Upgrading Energy Regulations for the Energy Regulatory Commission (ERC) of the Philippines

Focus Group Discussion Amendment to PGC

28 February 2023
09:00-15:15 hours

Presentation of Ricardo: Summary of Proposed Amendments

Proposed Protection Arrangements:

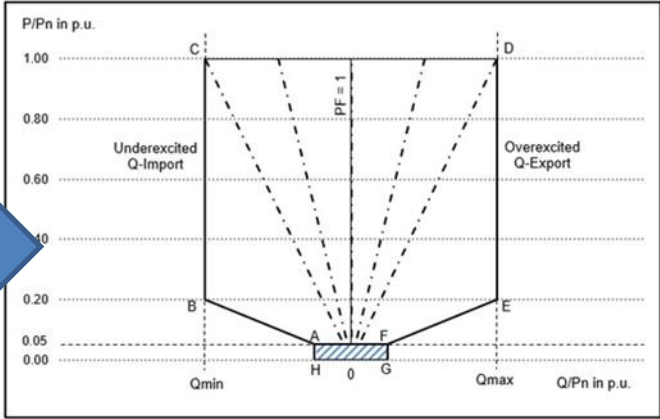
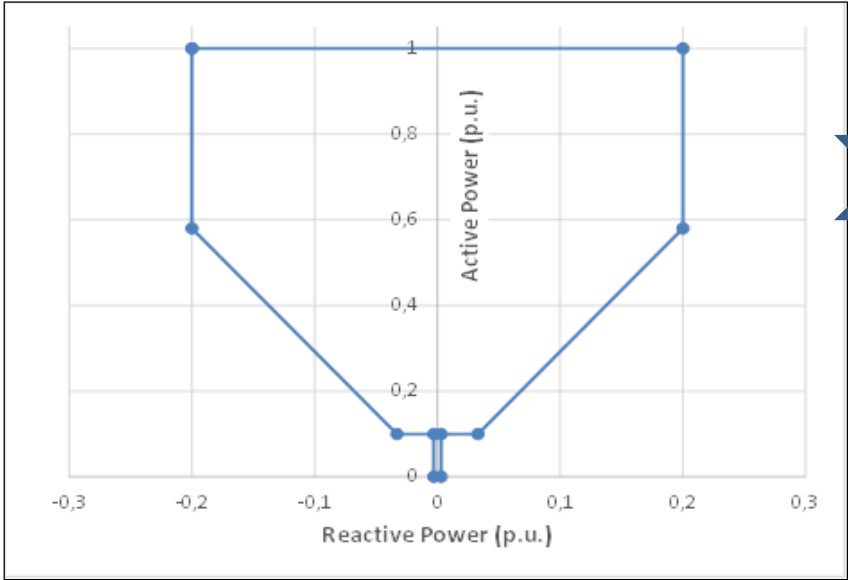
- 1) Protection coordination and prioritisation based on IEEE 2800-2022
- 2) The plant shall not energize the transmission system when the transmission system is de-energized. Except for Black Start.
- 3) The plant shall only enter into service or return to service when the frequency is in the range 59.5 Hz to 60.3 Hz and voltage is in the range 0.9 p.u. to 1.05 p.u.
- 4) Large Wind and PV shall not cause rapid voltage change at the POC to exceed 2.5% of nominal voltage.

Voltage Control Requirements

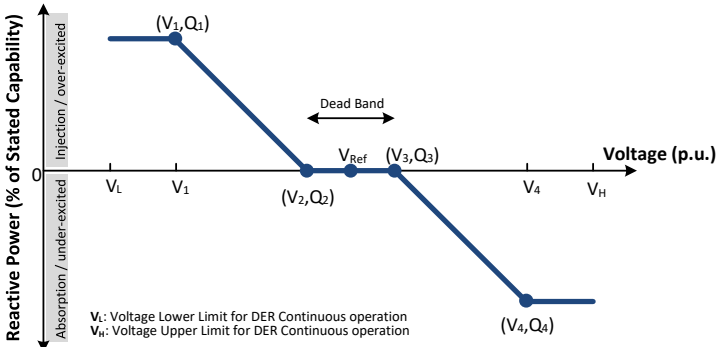
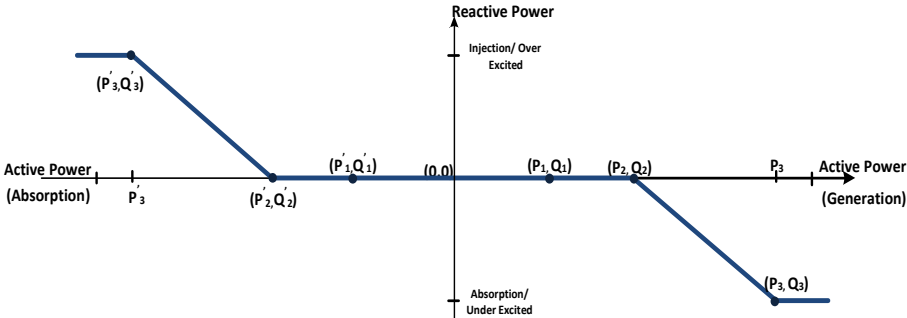
IEEE 1547-1018 voltage-reactive power requirements

IEEE 1547-2018 active power reactive characteristic

Proposed to be applicable to IBESS including Large Wind, Large Solar, Conventional Energy Storage and Inverter Based Energy Storage System

PGC Wind turbine fault ride through capability – section GCR 4.4.3.4.1

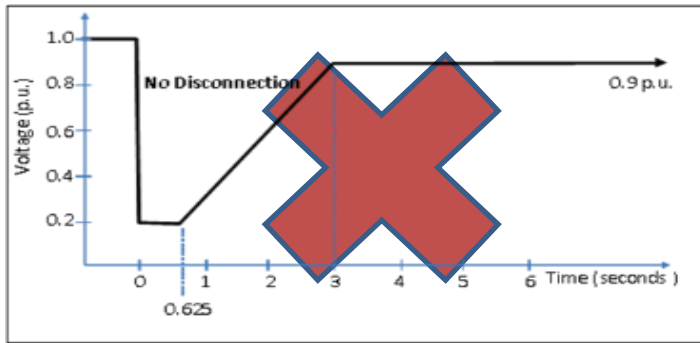
PGC Wind proposed to be aligned to PDC and IEEE 2800-2022

Inverter Based Reactive Power Generation During Faults

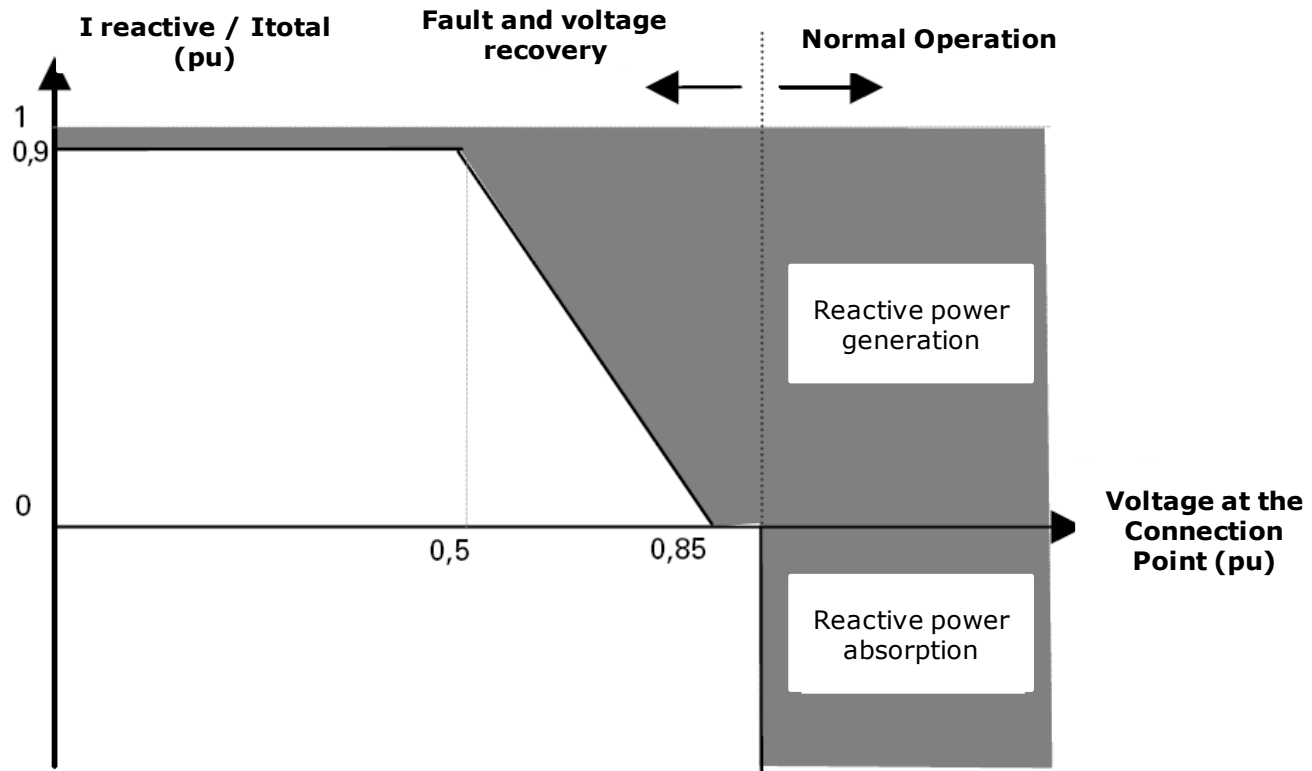
Proposed alignment to IEEE 2800-2022 7.2.2.3 and ACER

IESS Connection Requirements

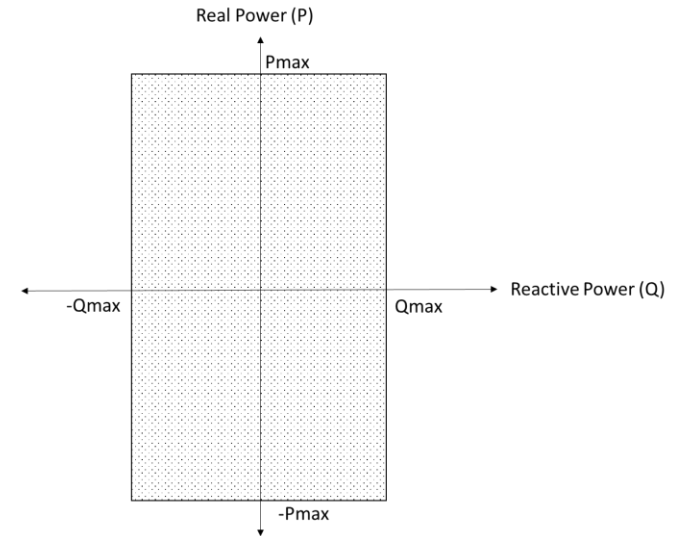
Proposed Additional requirements to Wind and PV are:

- 1) Reactive power capability required when charging
- 2) Voltage control capability required when charging
- 3) Real power control required when charging
- 4) Additional data requirements such as energy storage capability, maximum charging capacity and maximum charging rate
